BOLTON COLLEGE

DRAINAGE TECHNICAL NOTE

Report Reference: BCC-RDG-00-ZZ-RP-C-0002

2.0 Drainage Related comments and Ridge Response

EXISTING DRAINAGE LAYOUT				PROJECT REFERENCE: 3694
SCALE	SHEET	DRAWING No	REV	
1:100	A1	BCC-RDG-00-ZR-C-0001	P1

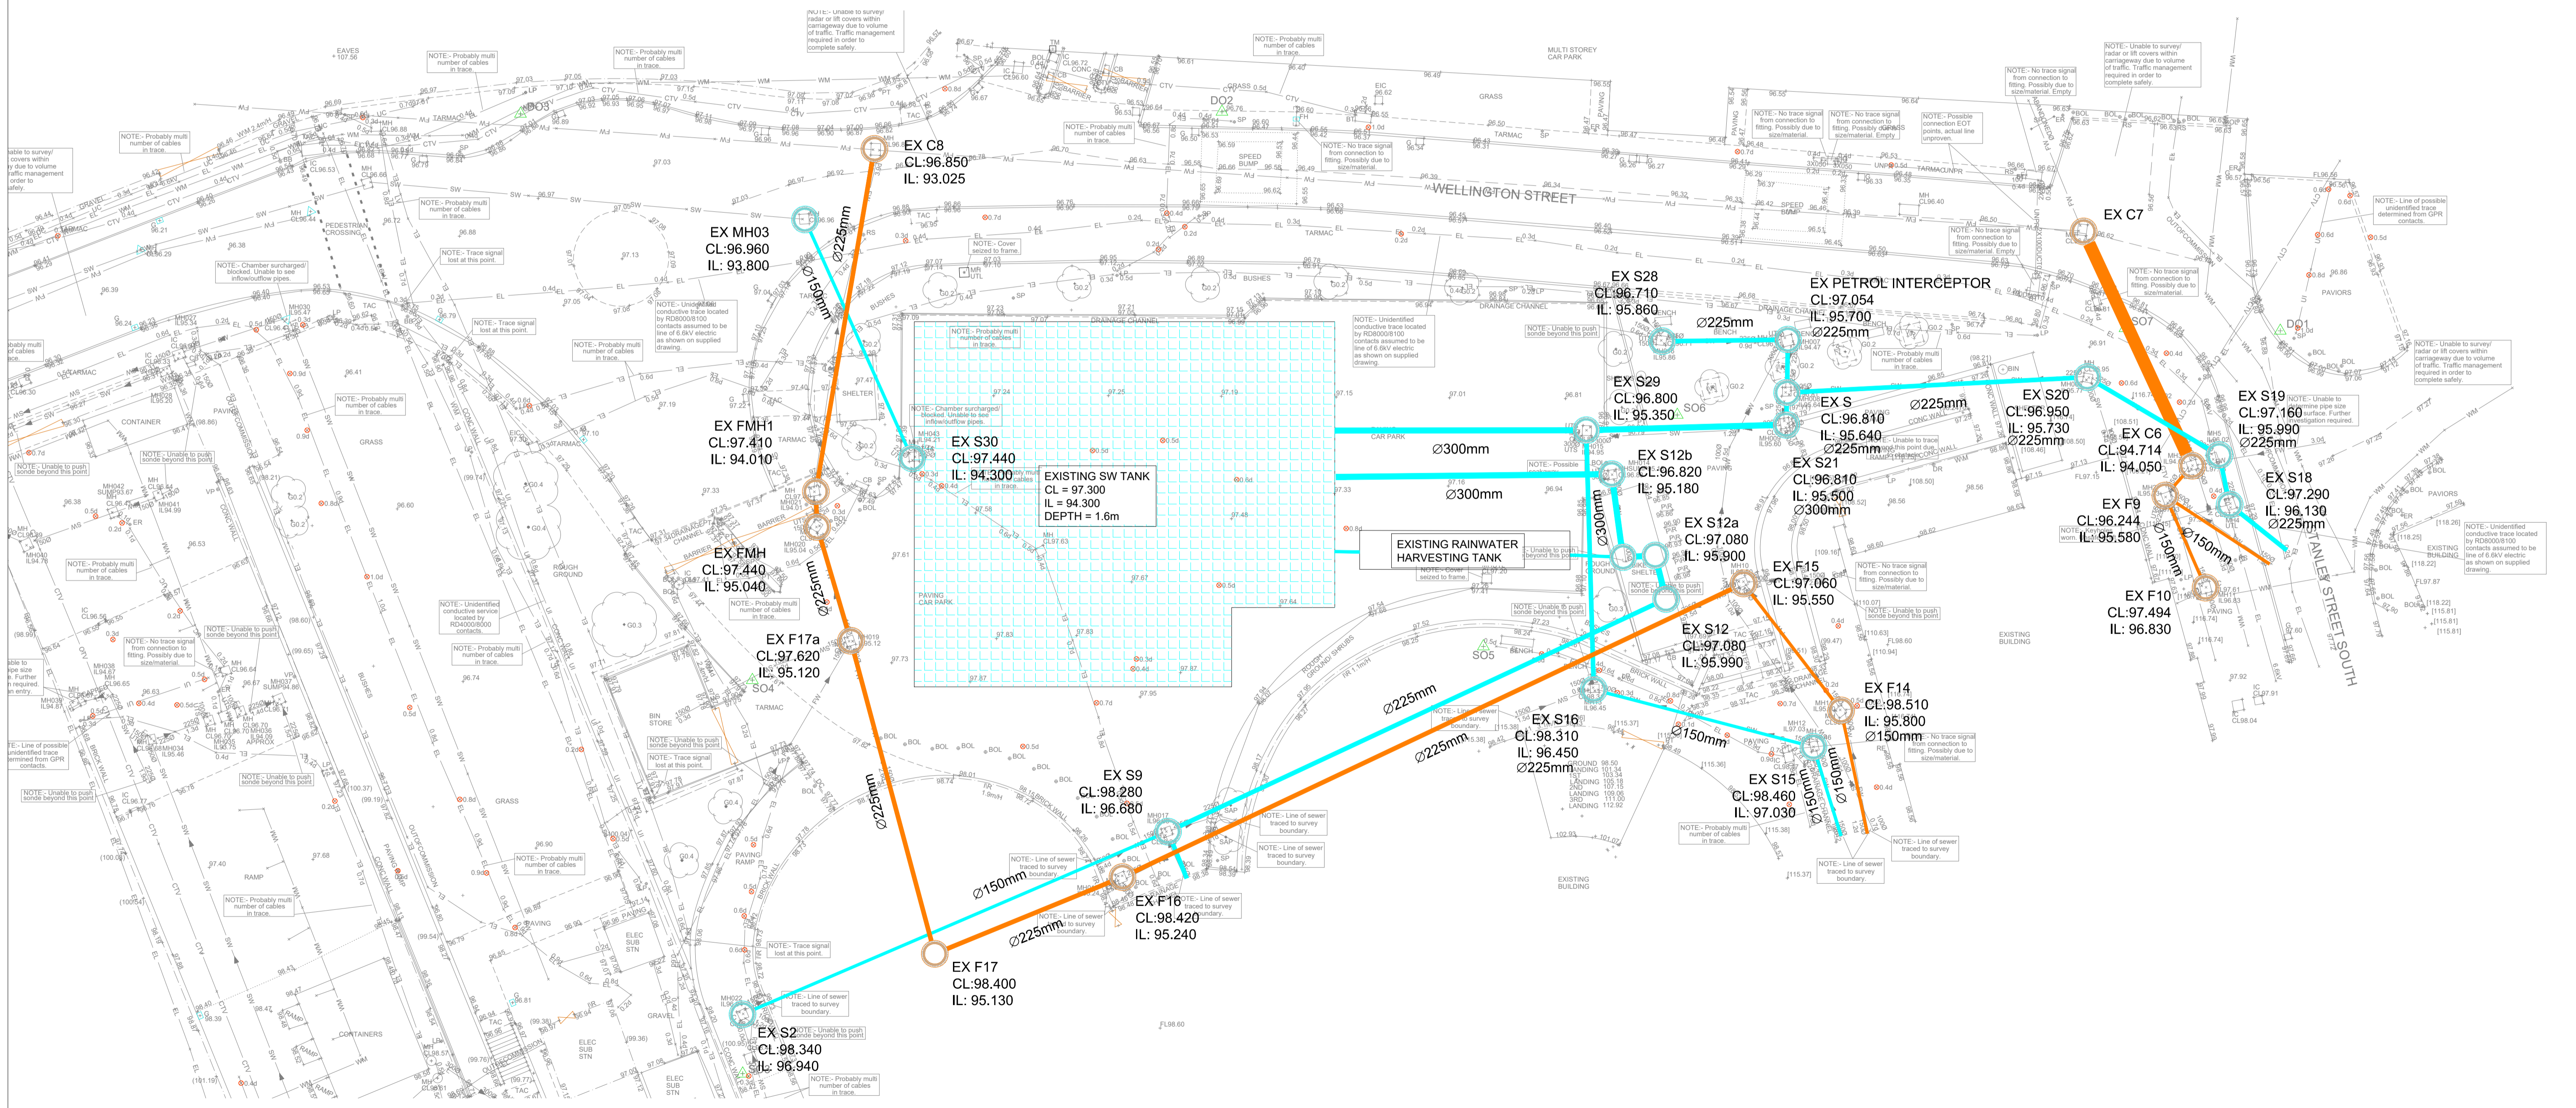
2) Include a timetable for its implementation, and);

Not applicable as the proposed SW system is to discharge into the existing SW system which is currently restricting flow to a maximum 15 l/s.

The Existing and Proposed Drainage GA plans are located within **Appendix B**.

PROPOSED DRAINAGE LAYOUT				PROJECT REFERENCE: 3694
SCALE	SHEET	DRAWING No	REV	
1:100	A1	BCC-RDG-00-ZZ-DR-C-0002	P3

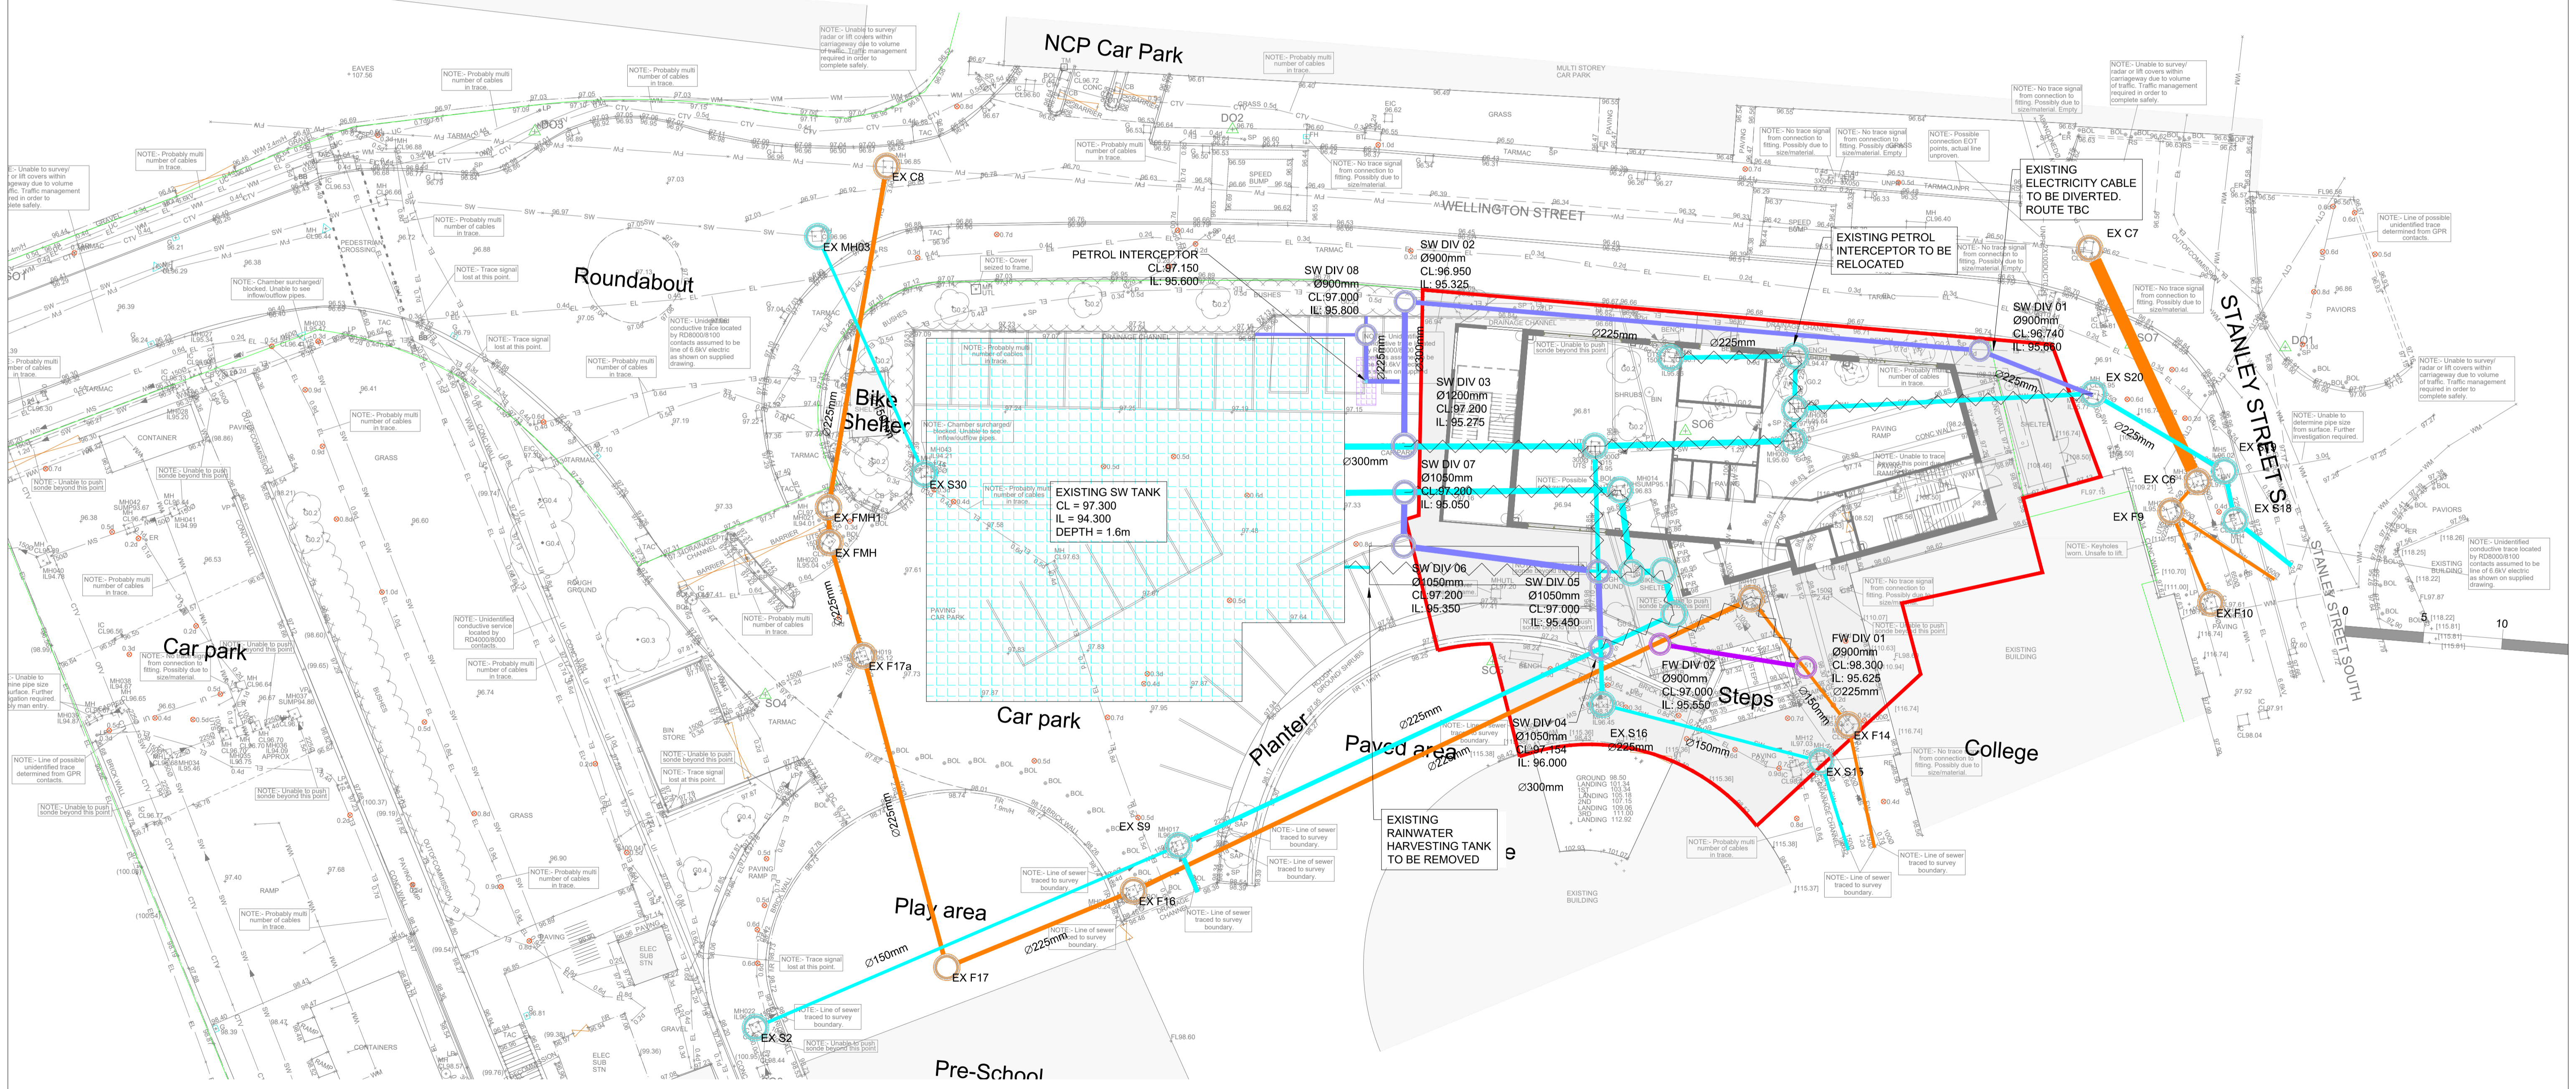
1) Provide information about the design storm period and intensity, the method employed to delay and control the surface water discharged from the site and the measures taken to prevent pollution of the receiving groundwater and/or surface waters.

As part of the proposed drainage works, diversion of the existing private SW system around the proposed new building will be required.

A petrol Interceptor is to be located prior to the existing SW attenuation tank; this measure will stop any pollutants from being discharged from the development.

The new building is utilising the attenuation tank already being used for the car park etc and already has a restriction to the public sewer.
It is proposed that some re-routing of the surface water network will be required to accommodate the building's footprint which is showed on the Proposed Drainage Layout - BCC-RDG-00-ZZ-DR-C-0002
The LPA is advised to condition this and make this the approved drawing.
